ADDENDUM NO. 02

Documents: MD101, M201.

UNIVERSITY OF SOUTH CAROLINA
UNION CAMPUS
BOILER REPLACEMENT

MECHANICAL/ELECTRICAL DEMOLITION PLAN

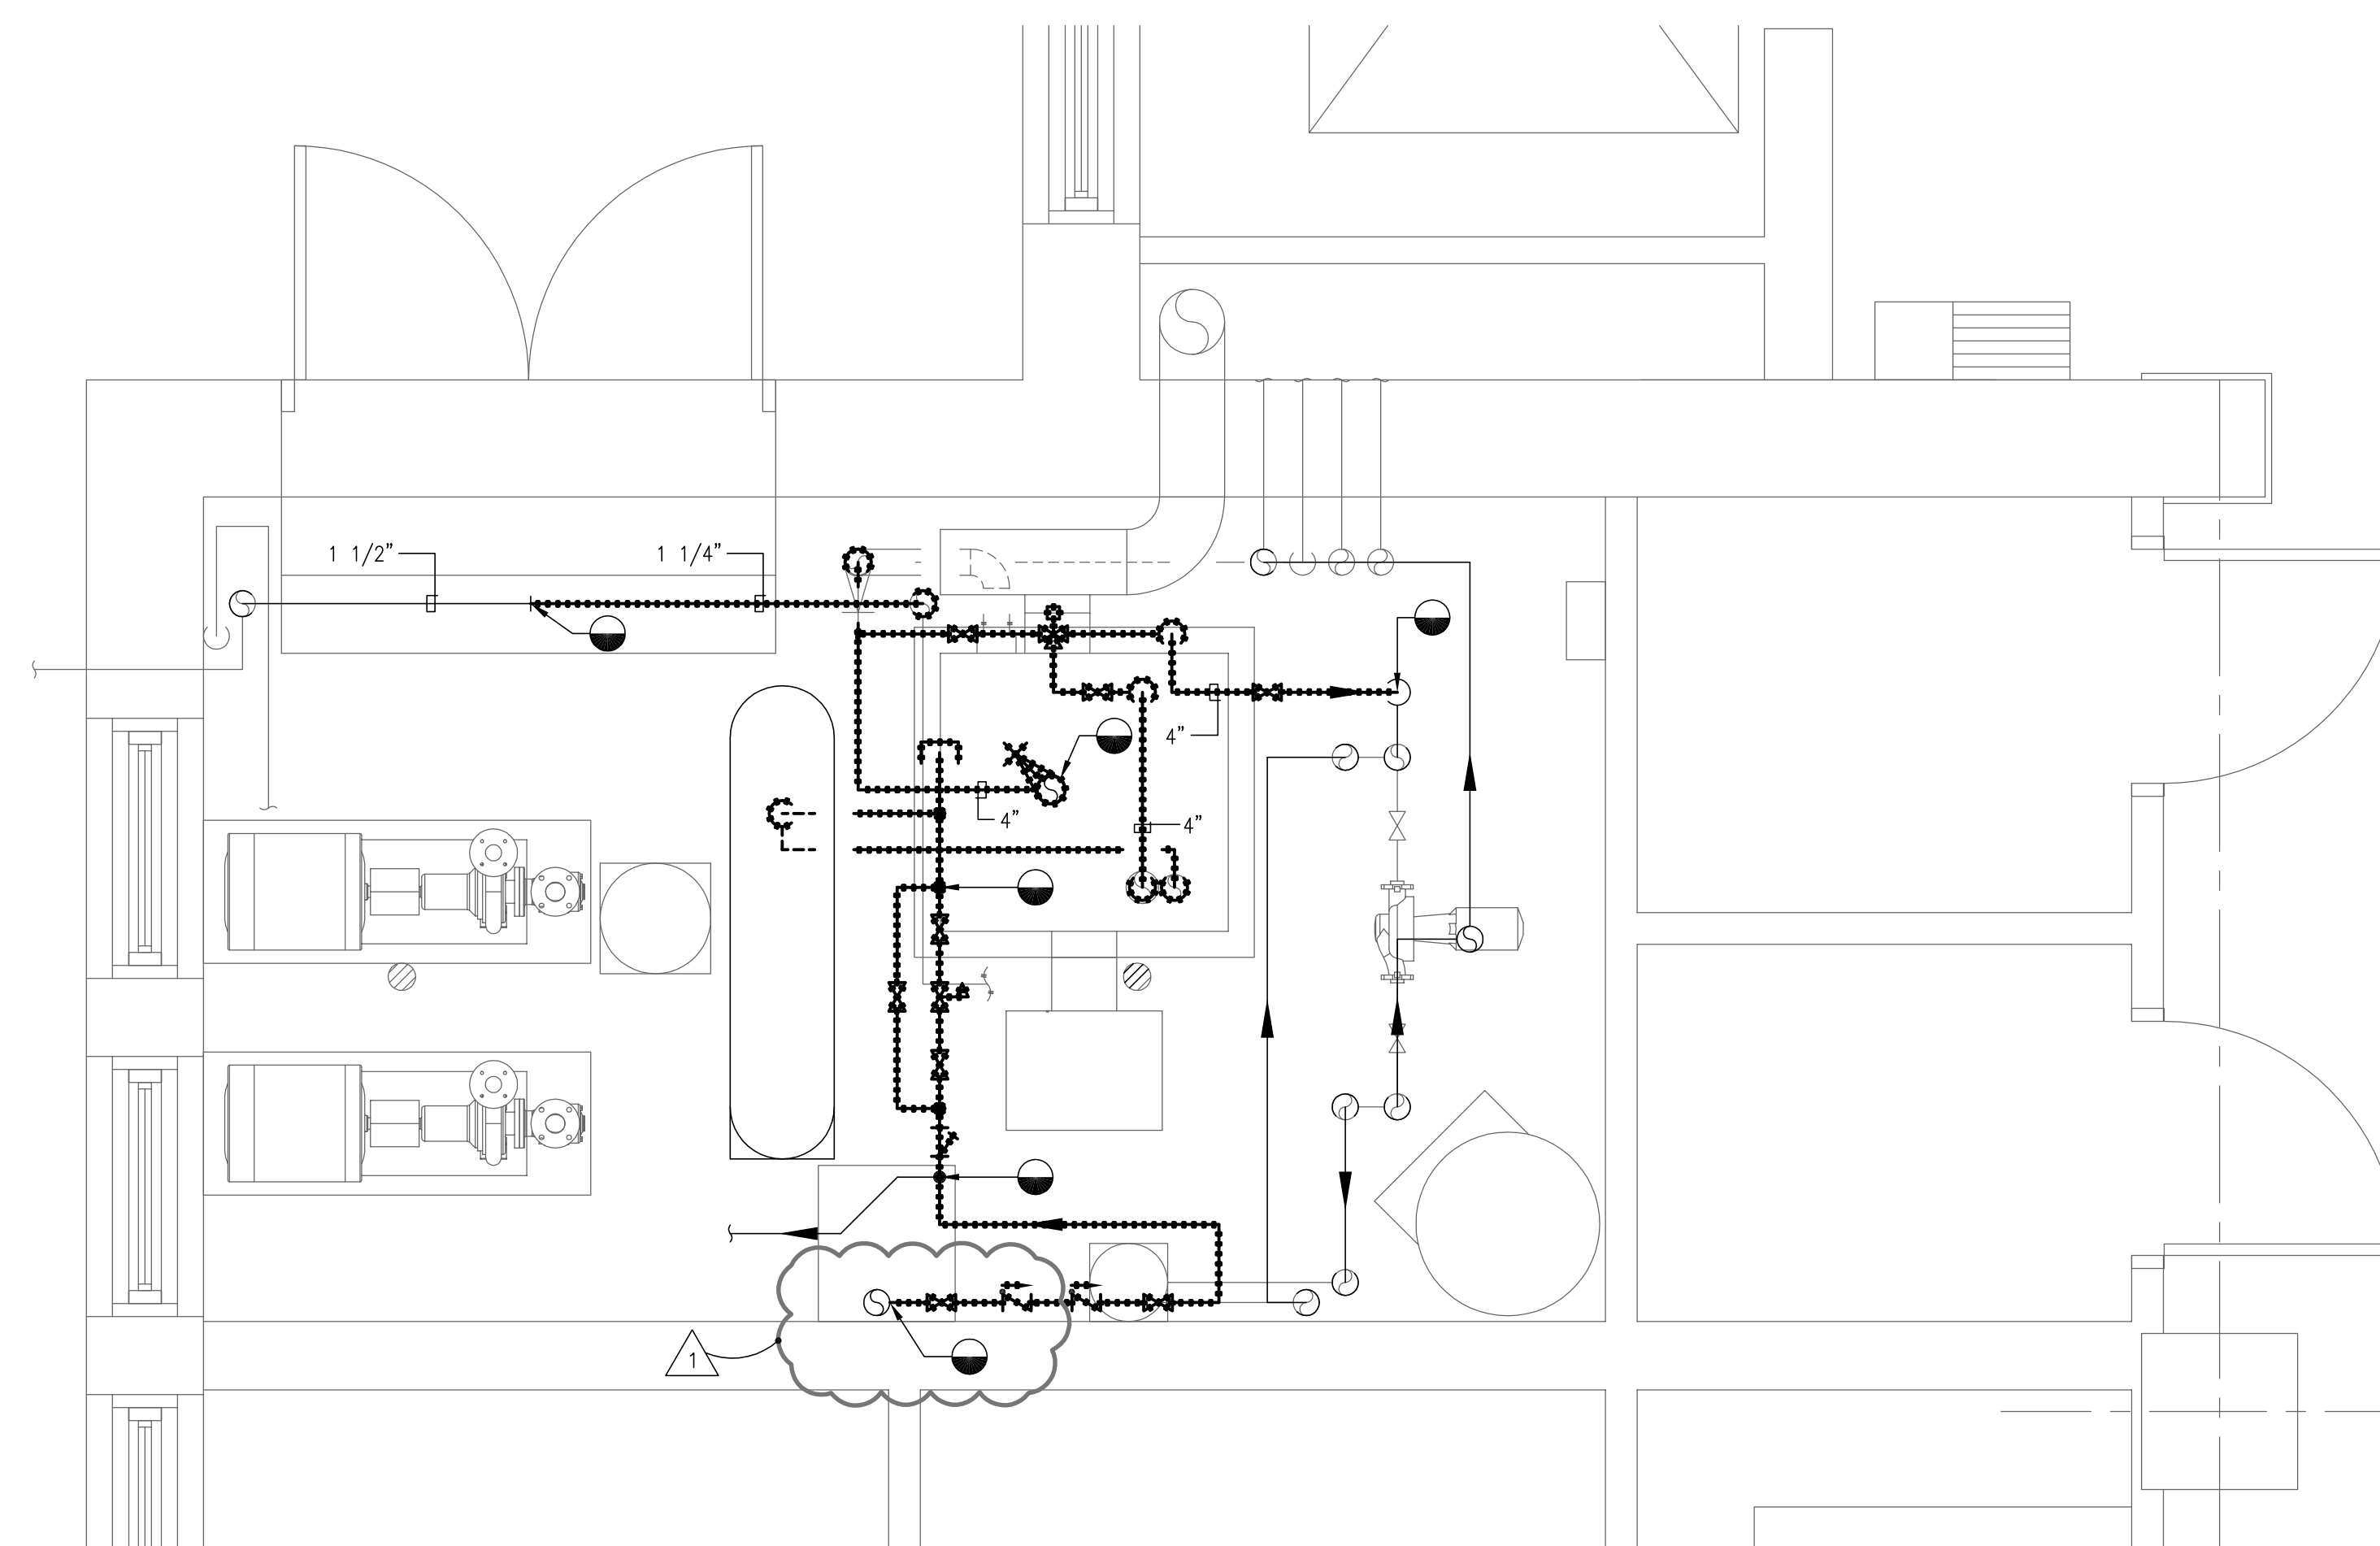
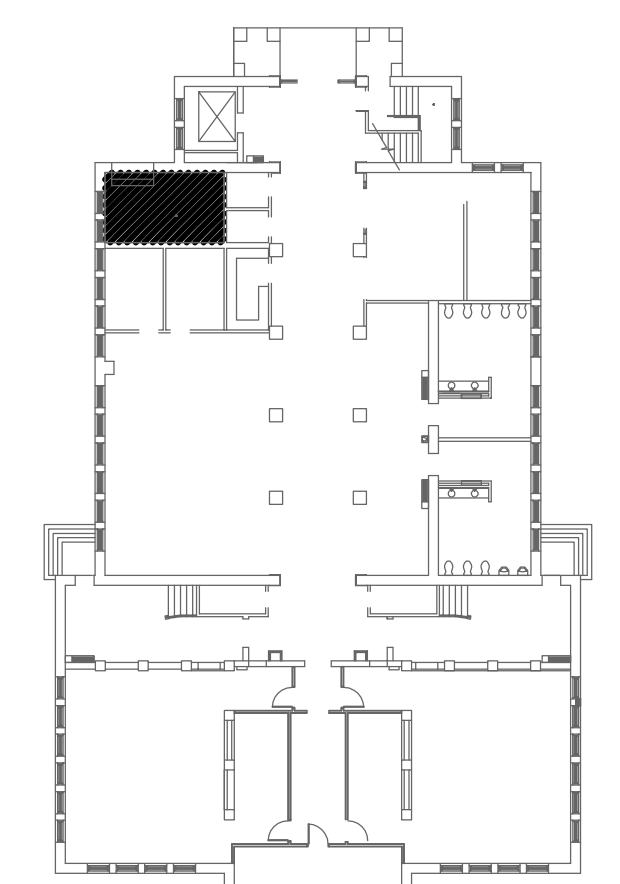
| 2. | MD101 – MECHANICAL/ELECTRICAL DEMOLITION Update drawing MD101 to include domestic water valve demolition as indicated by revision #1, Addendum #2, dated 10-24-2014. |
